T/R Dual Lock Duplex Bearing Support

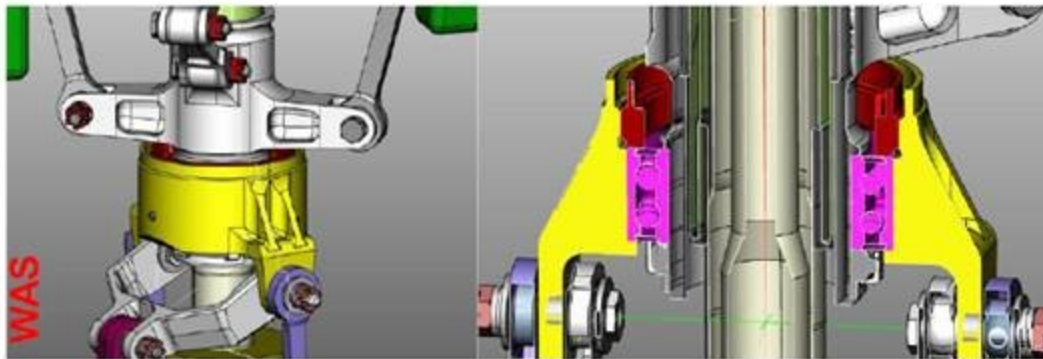
- Installation of the Duplex Bearing locking nut requires several steps including cleaning and use of Loctite products.
- Demand to improve locking system.

- New Support configuration, with improved maintainability and more robust Locking System, similarly to the Main Rotor Swashplate installation.
- Compatible with current Duplex Bearing.

- Target for certification Q4 2022.
- Retrofit through SB.
